*Standard 7-16*  
*Minimum Design Loads and Associated Criteria*  
*for Buildings and Other Structures*

**SUPPLEMENT 1**

Effective: December 12, 2018

This document contains CHANGES to the above title, which is posted on the ASCE Library at <https://doi.org/10.1061/9780784414248>

**FIGURE C6.6-3 Example EGLA with adjustment where an Inundation Depth Point is specified in the ASCE Tsunami Design Geodatabase**

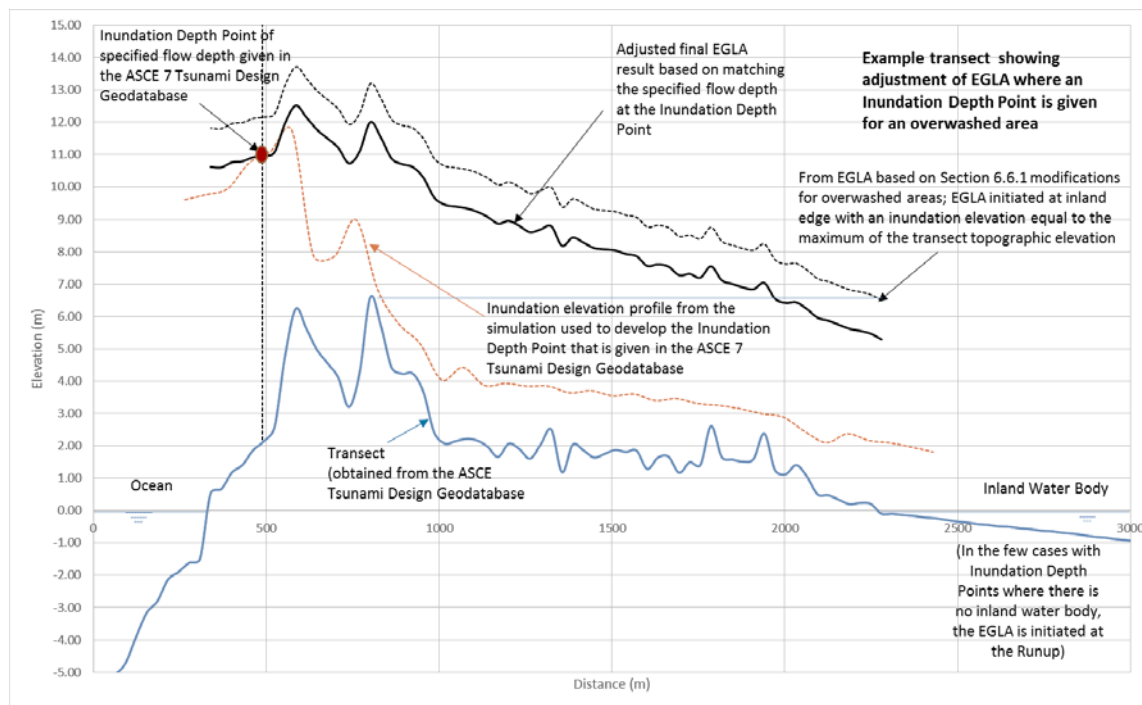
\*Where Inundation Depth Points are provided for completely overwashed areas in the ASCE Tsunami Design Geodatabase, where the tsunami flows over an island or peninsula into a second water body, the horizontal distance of the inundation limit shall be taken to be the length of the overwashed land. There are two modifications of Section 6.6.1 given for this case relating to the initial conditions of nonzero depth and velocity at the inland edge of the overwashed area and the Froude number profile that follows a linear interpolation with distance across the overwashed land. To complete the analysis, the inundation elevation profiles are adjusted so that the computed inundation depths are at least the depths specified at the Inundation Depth Points. The adjusted inundation elevation profile should not be lower than the topographic elevation transect. An example is given in Fig. C6.6-3.
